**MICROCHIP****PIC16F882/883/884/886/887**

PIC16F882/883/884/886/887 Silicon/Data Sheet Errata

The PIC16F88X parts you have received conform functionally to the Device Data Sheet (DS41291D), except for the anomalies described below.

FIGURE 1: SCK PULSE VARIATION USING TIMER2/2

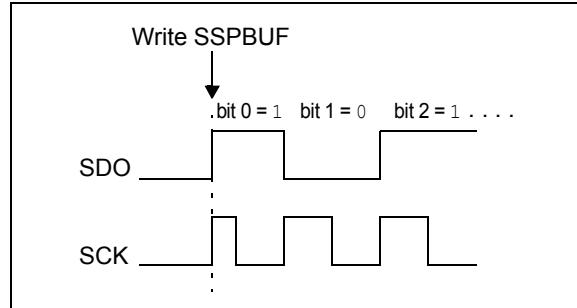
When the SPI is using Timer2/2 as the clock source, a shorter than expected SCK pulse may occur on the first bit of the transmitted/received data (Figure 1).

To avoid producing the short pulse, turn off Timer2 and clear the TMR2 register, load the SSPBUF with the data to transmit and then turn Timer2 back on. Refer to Example 1 for sample code.

FIGURE 3: ACTUAL (INCORRECT) OPERATION WITH CLOCK STRETCHING – EXAMPLE 1

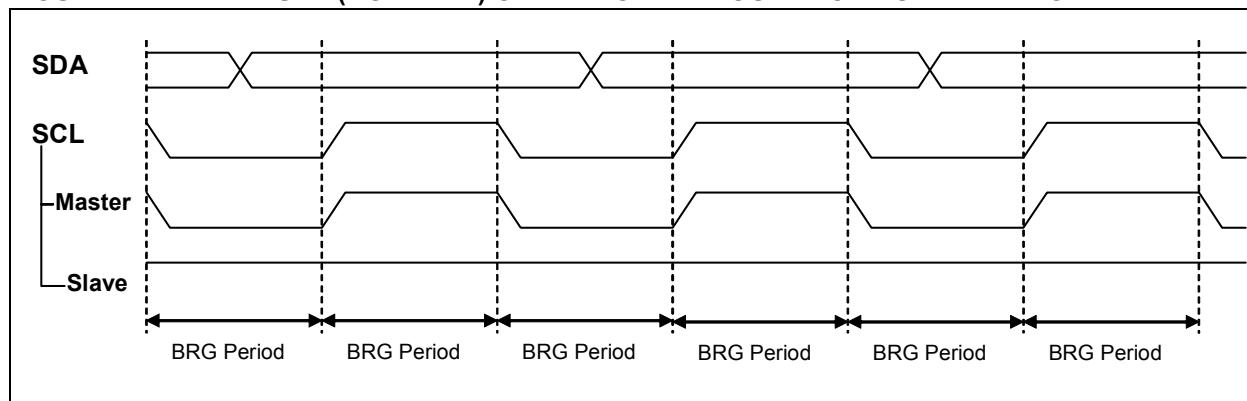
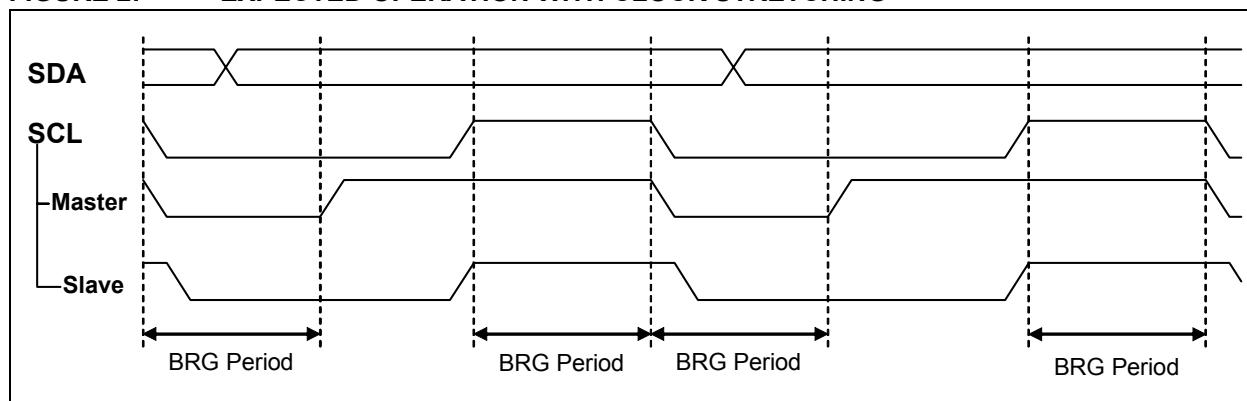
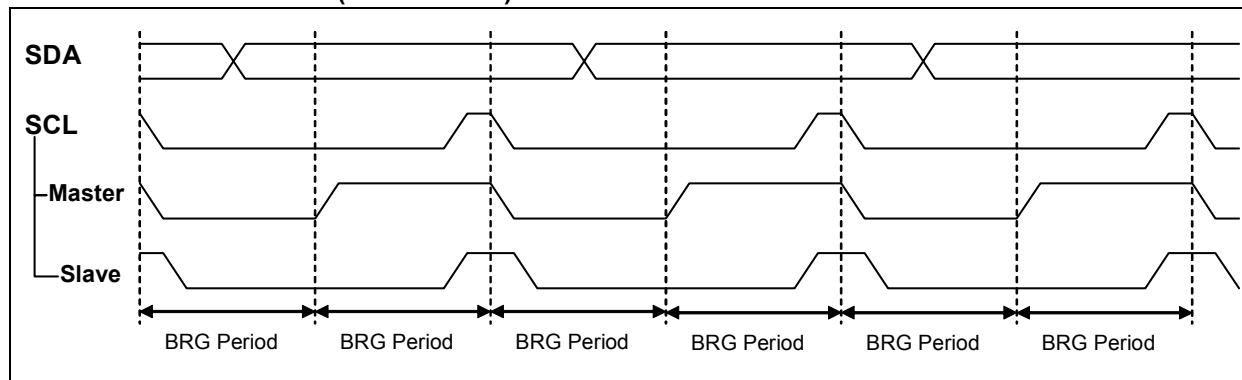
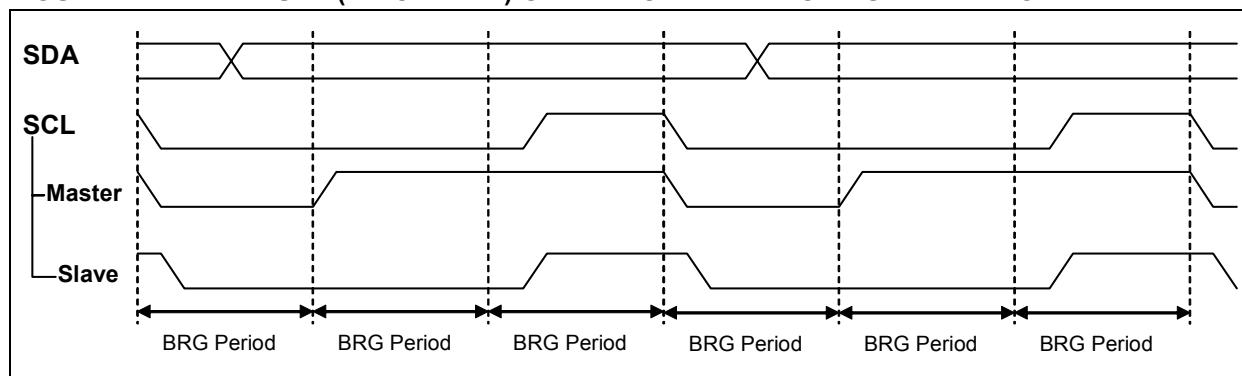
The current implementation does not guarantee accurate SCL high time. During clock stretch, the MSSP device will erroneously continue running the BRG counter. At the end of the clock stretch the BRG counter continues to count down for the

remainder of the BRG period, and then the MSSP device will immediately resume transmitting the data.

Figure 1 illustrates an expected I²C transmission in which the SCL line is completely controlled by the master device and the slave device does not attempt to stretch the clock period.

Figure 2 illustrates the expected operation of an I²C transmission in which the slave device has stretched the clock period by holding the SCL line low. The high time of the SCL pulse is constant, regardless of the duration of the clock stretch.

Figure 3 and Figure 4 illustrate an actual I²C transmission in which the slave has stretched the clock period by holding the SCL line low. Note that the high time of the SCL signal has shortened from the expected time.

Set the communication speed to match the slowest device on the bus. This ensures that no slave device will perform clock stretching.

It is possible to dynamically adjust the communication speed to match the device being addressed by modifying the BRG register. However, the behavior of slower slave devices must be understood and speed adjustments made such that no slave performs clock stretching.
